Three Point Torso Restraint System
Raytheon (BEEHCRAFT) 33/35/36 - 55/56/58/95 Aircraft

FAA /STC SA01880CH EASA/STC 10071581

INSTALLATION AND MAINTENANCE MANUAL

**ADDENDUM NUMBER 2
STC SA01880CH**

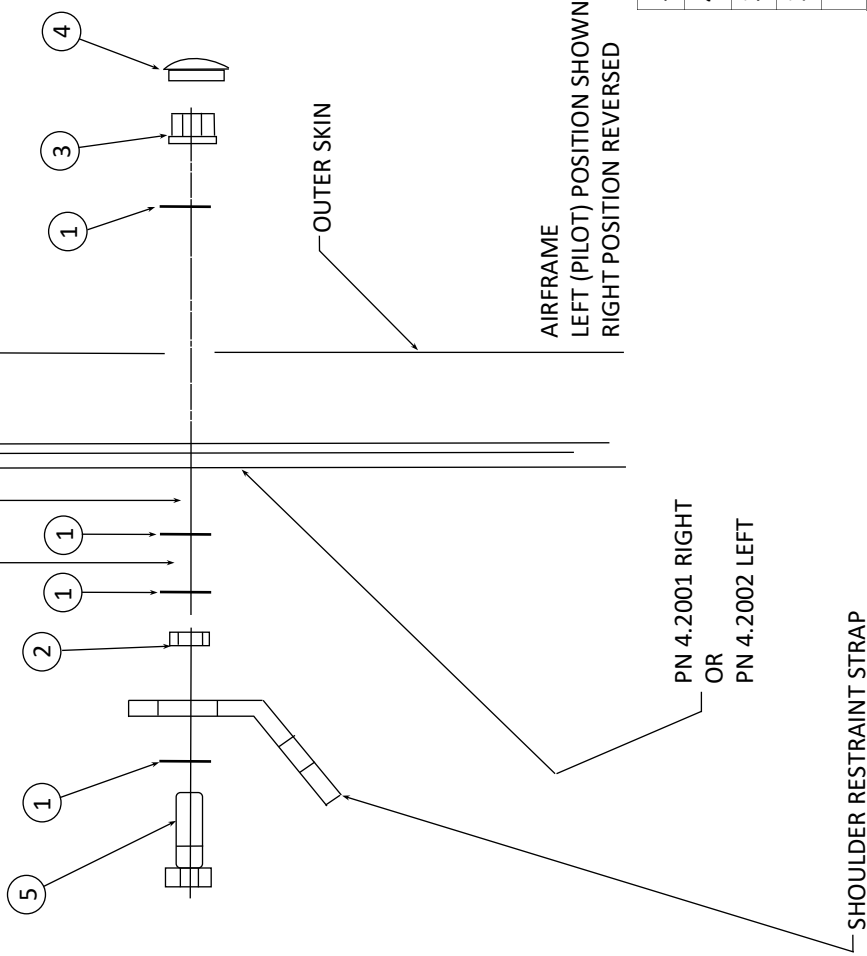
NOTE 1 - LEFT, E/W INTERIOR ROYALITE TRIM / MAY REQUIRE AN ADDITIONAL AN960-416 WASHER FOR SPACING.

NOTE 2 - RIGHT, E/W INTERIOR ROYALITE TRIM / CHANGE ITEM 6 TO AN4-12A, ADD 1/4" X 1/2" SPACER, PN 4.2600 OR AN/MS/NAS EQUIVALENT.

C	6/28/04	ADD NOTES 1 + 2
B	8/20/03	DETAIL CHANGE
A	8/10/03	ISSUE
REV	DATE	DESCRIPTION

REV.	4.3008	REV. D
RESTRANT BELT GUIDE	4.3008	D
Alpha Aviation Burnsville MN.		
FIN: N/A	TOL XX+/- .03, XXX+/- .010. OR NOTED	
DRAWN	MCW	CHK. APPR.

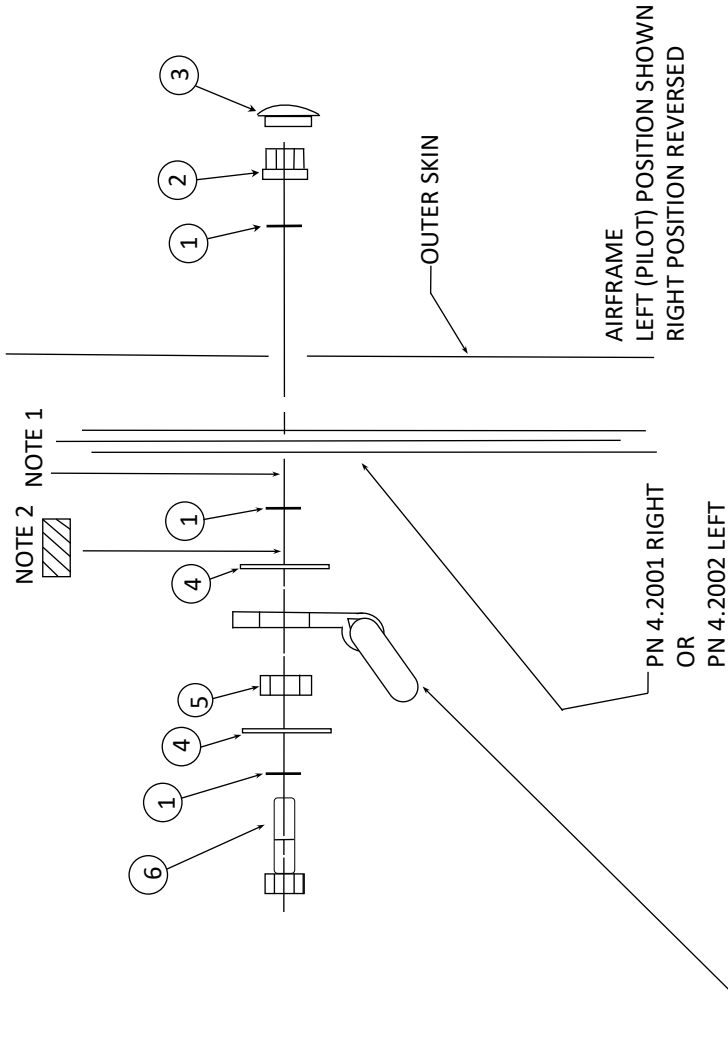
NOTE 1 - LEFT, E/W INTERIOR ROYALITE TRIM / MAY REQUIRE AN ADDITIONAL AN960-416 WASHER FOR SPACING.

NOTE 2 - RIGHT, E/W INTERIOR ROYALITE TRIM / CHANGE ITEM 6 TO AN4-13A, ADD 1/4" X 1/2" SPACER, PN 4.2006 OR AN/MS/NAS EQUIVALENT.

NOTE 3 - HARDWARE ITEM 4; UPSIZE THE THROUGH HOLE TO 2.65, 17/64" DRILL SIZE TO ACCOMMODATE THE AN4 BOLT.

REV	DATE	DESCRIPTION
D	4/15/13	ADD NOTE 3
C	6/28/04	ADD NOTES 1 + 2
B	8/20/03	ADD SPEC
A	8/10/03	ISSUE

58 – 58A Aircraft

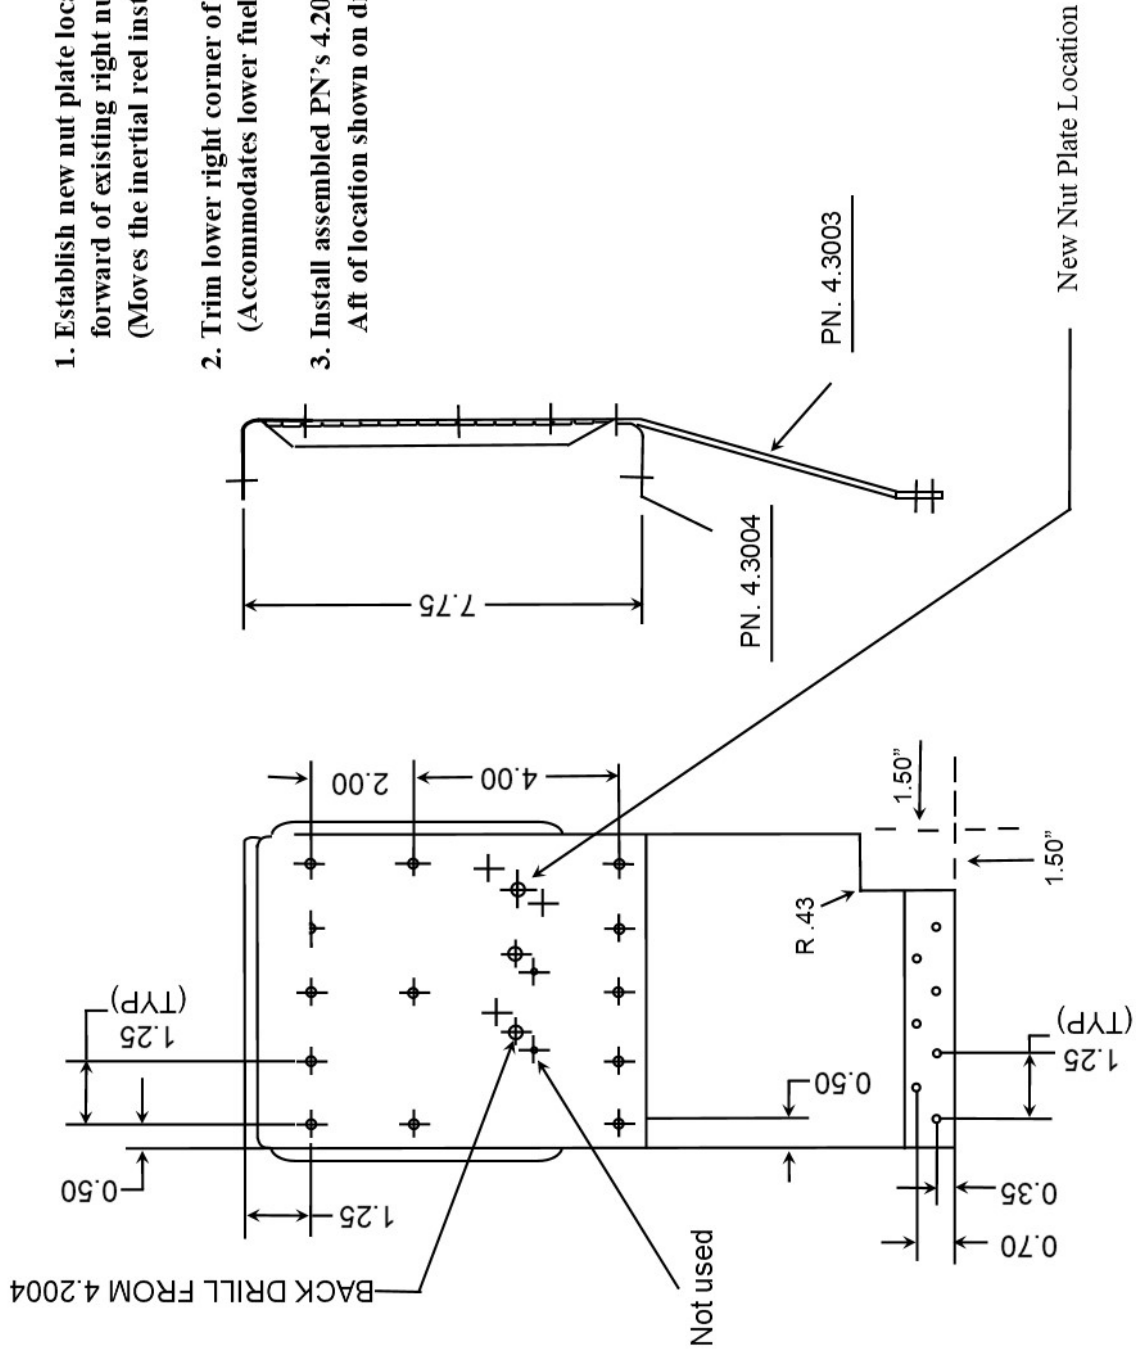
A small number of early production 58 and 58A aircraft incorporated an optional wet wing tip fuel system installation.

Aircraft so equipped will require the relocation of the assembled inertial reel bracket, PN's 4.2003 and 4.2004, 1.50 inches aft to accommodate the upper fuel cross feed line.

Relocation of the inertial reel on the assembled mount 1.50 inches forward.

Details of these changes are shown on the attached Addendum #2 drawing.
